Stag Brewery, Mortlake

Masterplan and Detailed Design and Access Statement - Addendum

Fire-Led Design Amendments

November 2023

Proposed Scheme - Building 08 Typical Floor Plan

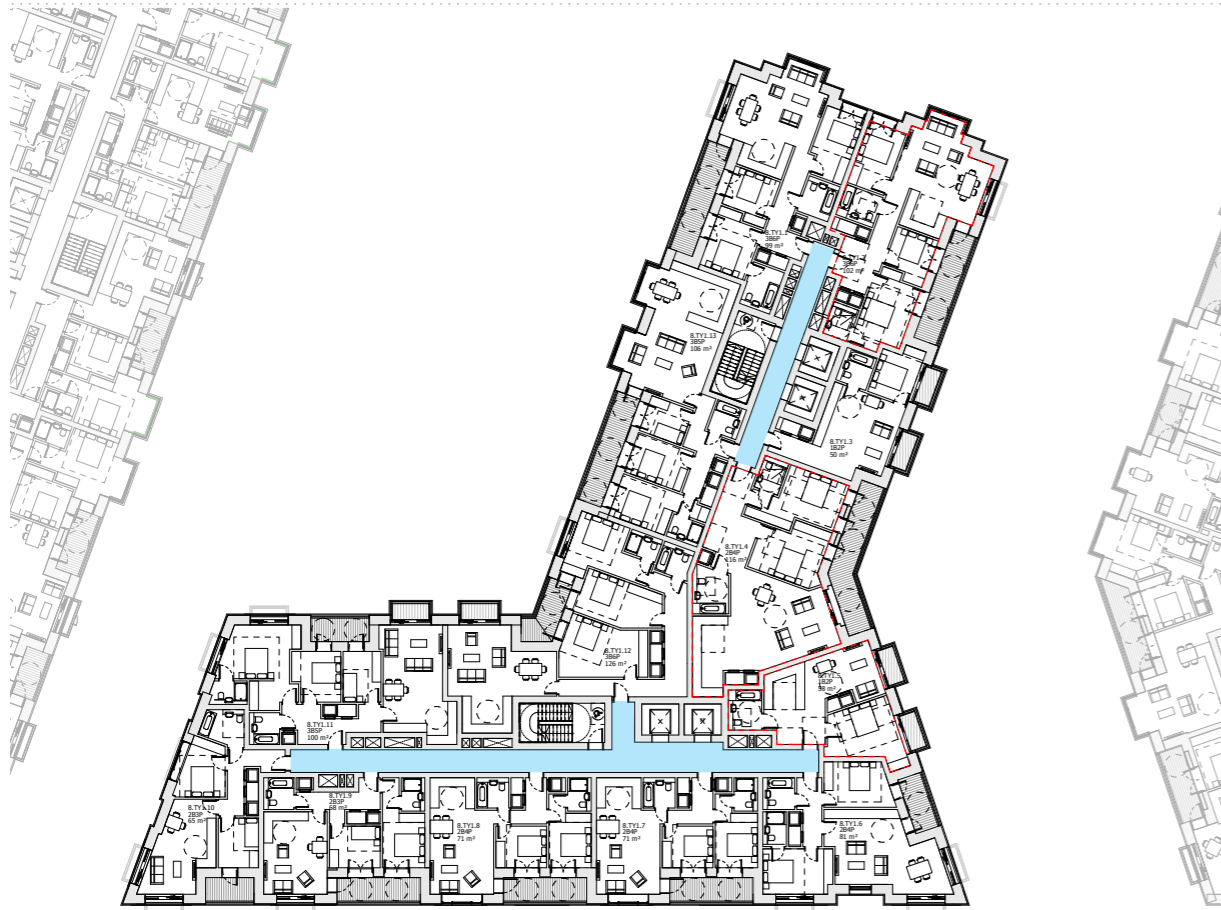
As per the previous buildings these amendments proposed to join the two cores in building 8 together with a door in the centre of the corridor to keep the cores separate unless there is an emergency. This has resulted in some changes to the layout of the units in the centre of the building, including the wheelchair accessible units but no change to the number of units or habitable rooms.
